WILLIAMSON COUNTY, TEXAS

CHANGE ORDER NUMBER: 3

Project:	Southeast Loop Phase I
Roadway:	Roadway Improvements
CSJ Number:	T3346

Change Order No. 3

OGUARD (M10) (N) - 20

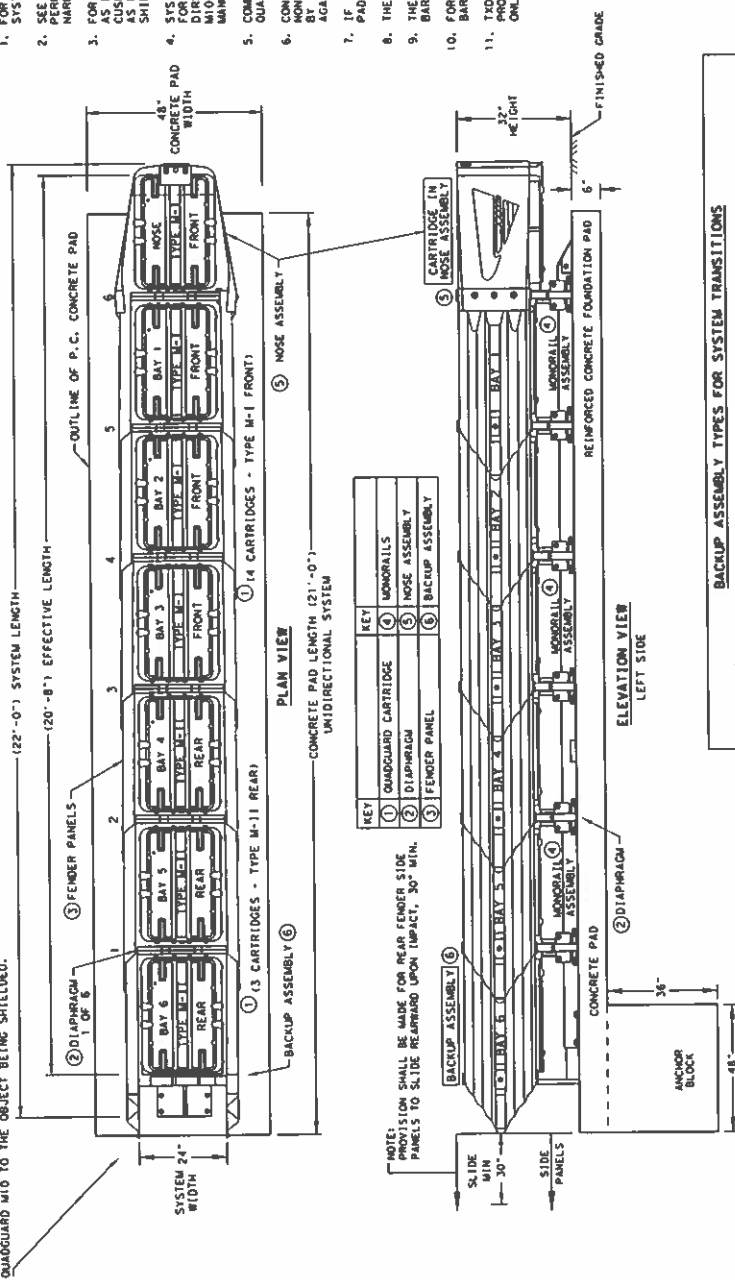
1A. Incorrect PS&E. This Change Order replaces the SGT and MBGF with Crash Cushion Attenuators on the proposed eastbound lane at both bridges due to them not being able to be installed per plan because of the post locations being in the MSE rock backfill. **2E. Miscellaneous difference in site conditions (unforeseeable)(Item 9).** This Change Order also compensates the contractor for replacing a portion of an existing concrete driveway that needed to be removed to install the 48in RCP on Line B35.

This Change Order replaces the end treatments (SGT's) and guardrail (MBGF) with permanent crash cushions on the eastbound side of both bridges. This is necessary due to the SGT's and MBGF not being able to be installed properly due to the retaining wall (MSE) rock backfill, MSE straps and storm drain that are in conflict. This Change Order also adds a concrete driveway item to the Contract, due to the contractor having to remove a portion of an existing driveway to install the 48-inch concrete drainage pipe (RCP). This existing driveway was constructed after the plans were generated.

The posts for the MBGF have a minimum embedment of 36 inches below finish grade. The top MSE wall strap is 1 ft below the top of the panel and about 2' below finish grade. The MBGF posts currently conflict with the MSE Wall straps at all 4 MBGF sections protecting the TY C221 Rail between the S.U.P. and the travel lanes.

The Eastern most 20 feet of MBGF posts at station 1184+50 conflict with EC80 line that is about 2 feet below grade at this location. Please advise

These crash cushions will be installed on each of 4 the approach slabs and tie into the vertical C221 barrier protecting the shared use path from the travelling public. The crash cushions will consist of 4 bi-directional TL-3 rated systems that will be drilled and epoxied to the approach slab. Because the approach slab steel was not designed with the crash cushion anchors in mind, additional labor will be required to drill through rebar (the manufactures foundations are designed so that steel will not conflict with the anchors.)

See the attached permanent crash cushion options with pictures of the eastbound side bridge ends, for consideration as solution to this RFI #45.

All eastbound side bridge corners (4) will now have a narrow TL-3 type permanent CCA installed on the bridge approaches. This may require concrete pad extensions off the end of the approaches, to make up for the extra 2 to 5 feet in CCA length required. This change will eliminate the originally proposed thrie beam, MBGF and SGT shown on the plans. Any necessary demo or extra work will be paid via Force account. Contractor to provide pricing for the 3 CCA options noted on the attached TxDOT sheets.
